# Comal County Environmental Health OSSF Inspection Sheet

**Permit of Authorization to Construct an On-Site Sewage Facility  
Permit Valid For One Year From Date Issued**

Permit Number: 116459  
Issued This Date: 09/27/2023  
This permit is hereby given to: Brian and Leslie Krause

2060 BELLA VISTA  
CANYON LAKE, TX 78133

Site Map  
Aerobic with Drip irrigation  
Brian And Leslie Krause  
Lot 68, Avonlea Subdivision  
2060 Bella Vista  
Canyon Lake, Texas 78133  
Comal County

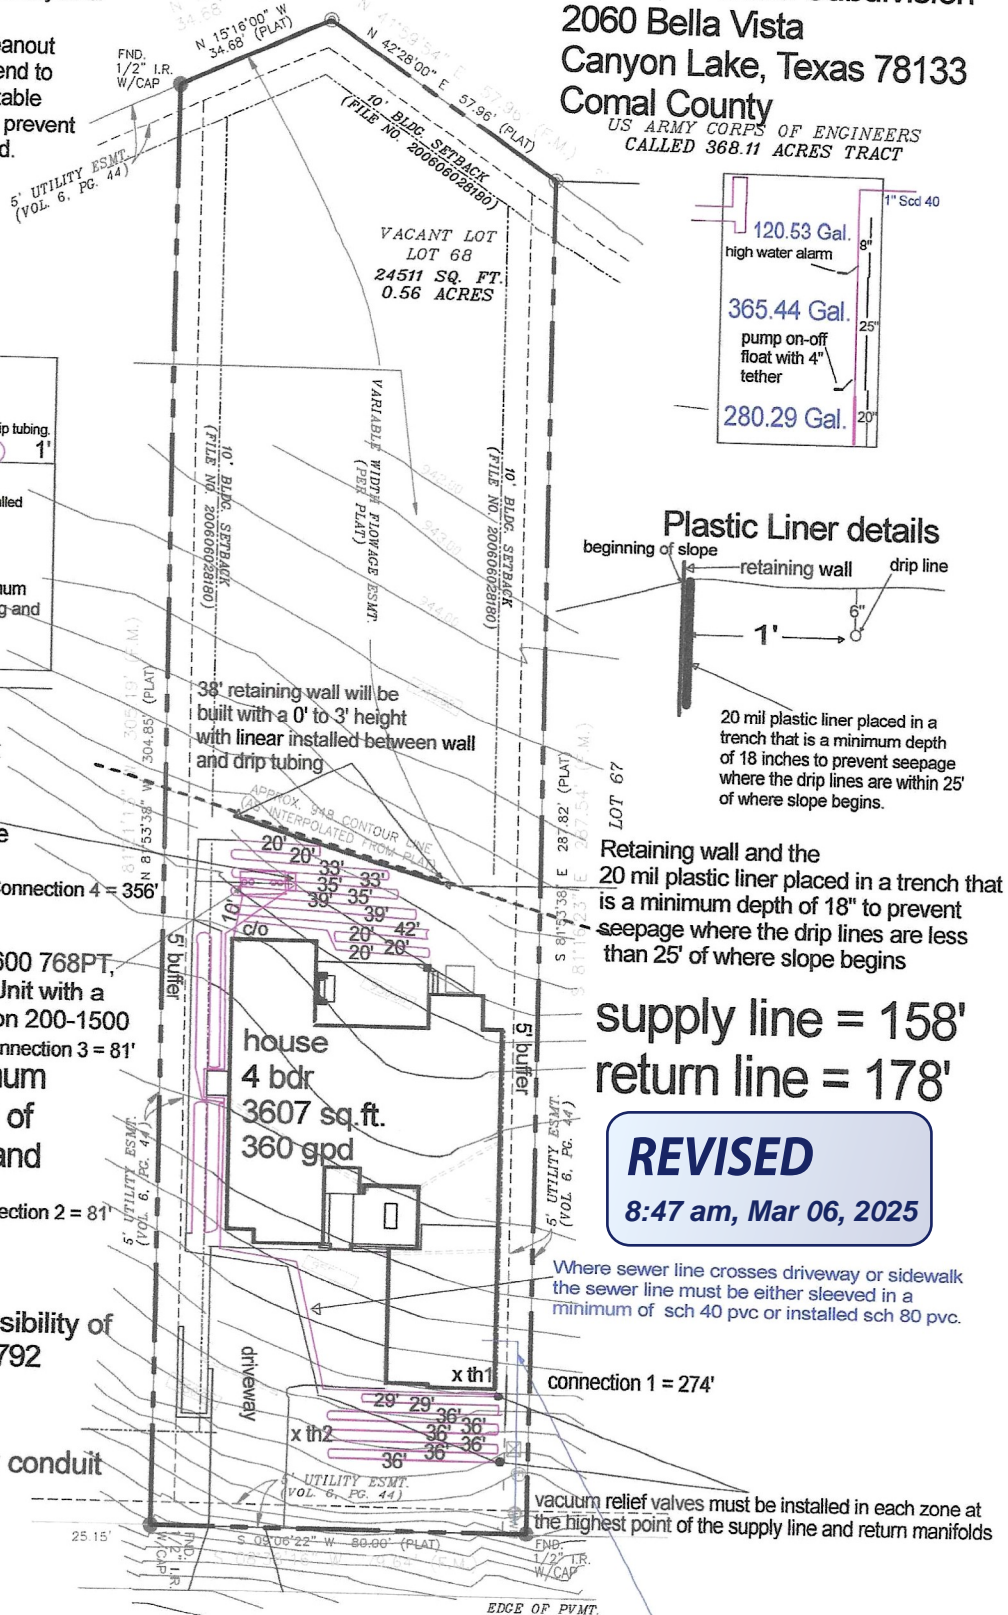
irrigation installed across tight line, tank and throughout drip field to be addressed by designer, requires re-inspection fee

**\*\*\*THE US ARMY CORPS OF ENGINEERS FLOWAGE EASEMENT  
BOUNDARY LINE / 948 LINE MUST BE CLEARLY MARKED AT  
THE TIME OF INSPECTION.**

Retaining wall and the 20 mil plastic liner placed in a trench that is a minimum depth of 18" to prevent seepage where the drip lines are less than 25' of where slope begins

supply line = 158'  
return line = 178'

Site Map  
Aerobic with Drip irrigation  
Brian And Leslie Krause  
Lot 68, Avonlea Subdivision  
2060 Bella Vista  
Canyon Lake, Texas 78133  
Comal County

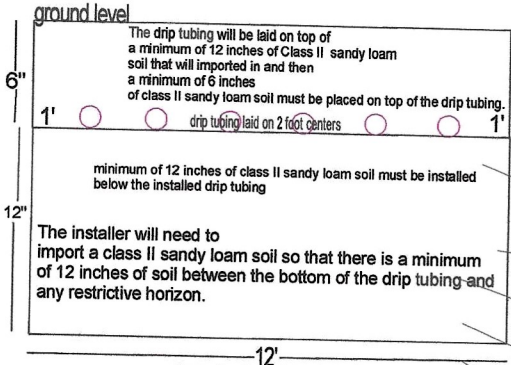
Here is the revised site map showing the liner to be installed to prevent seepage.

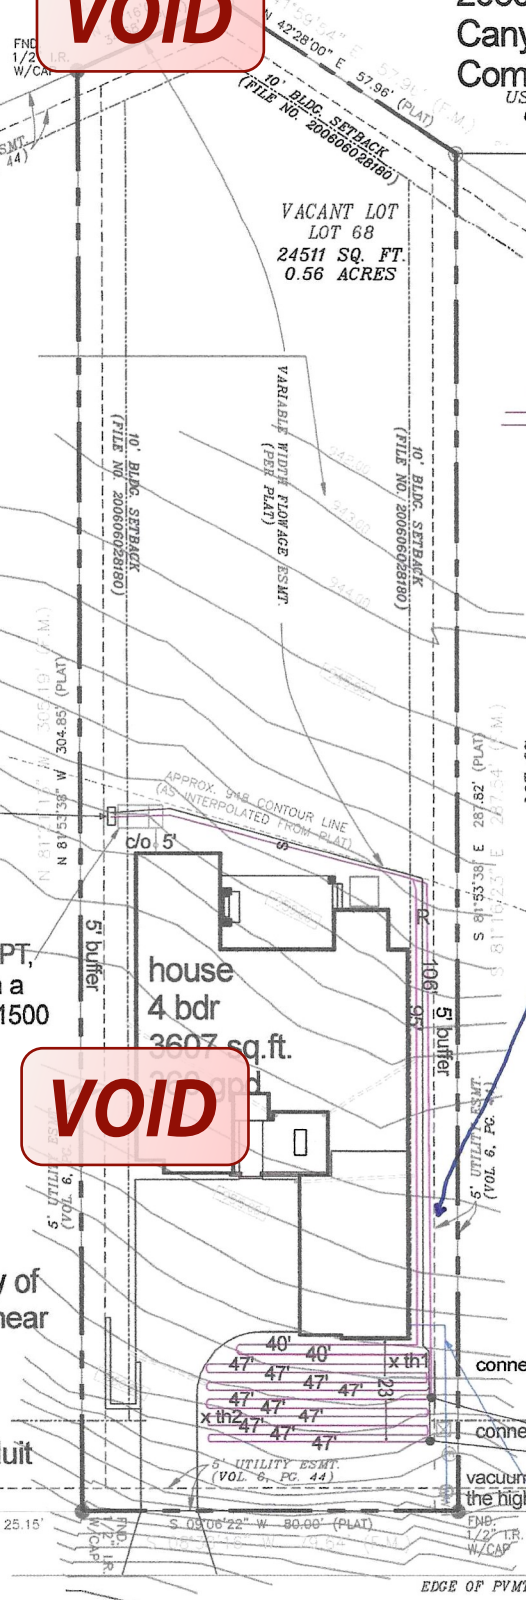
✓ Verify the required 1 ft. setback from the drip field to the easements.

Must maintain a 1' setback between the drip line and the utility elements

here is the revised site map addressing the setback from the utility easement

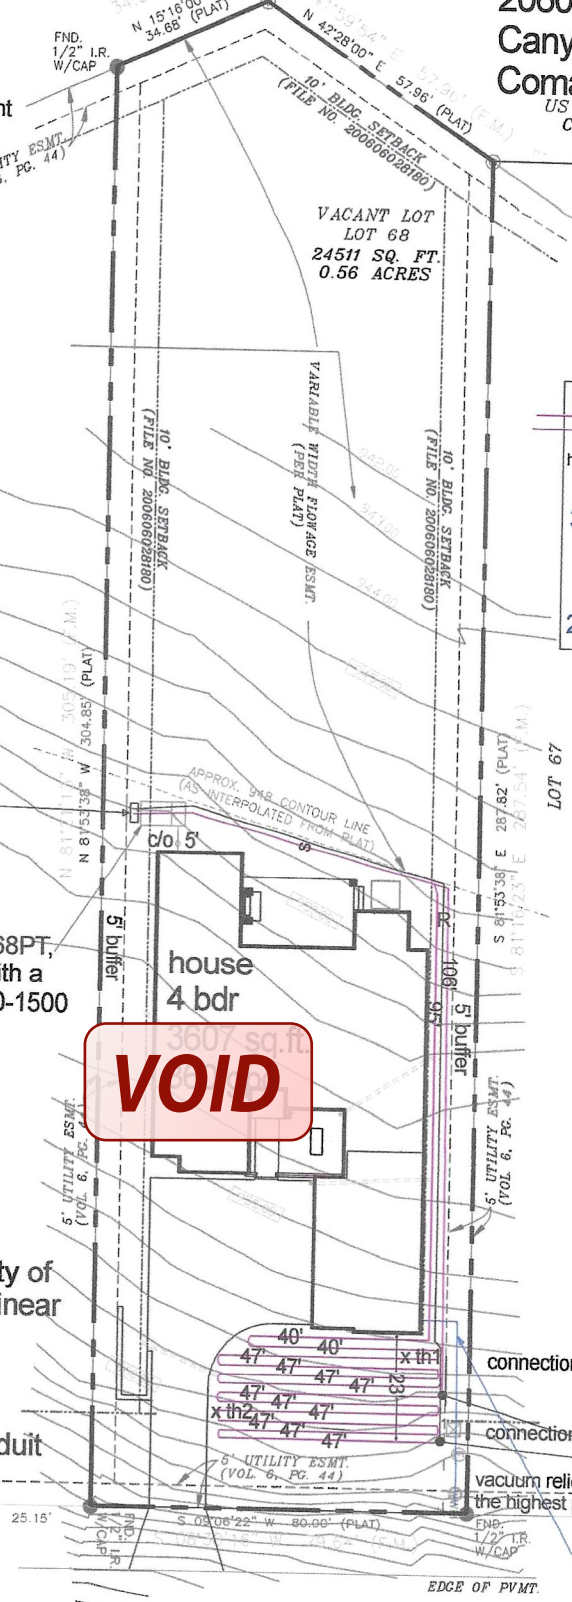
- ✓ The subdivision name on the design needs to be corrected.
  - ✗ The US Army Corps of Engineers (USACE) Flowage Easement is located at the 948 contour line. Revise the design accordingly. Be advised that you must provide documentation of approval from the USACE before the Permit to Construct will be issued..
  - ✓ A portion of the tanks are shown within the floodplain. Provide documentation on how tank flotation will be eliminated.
4. Revise as requested and resubmit.
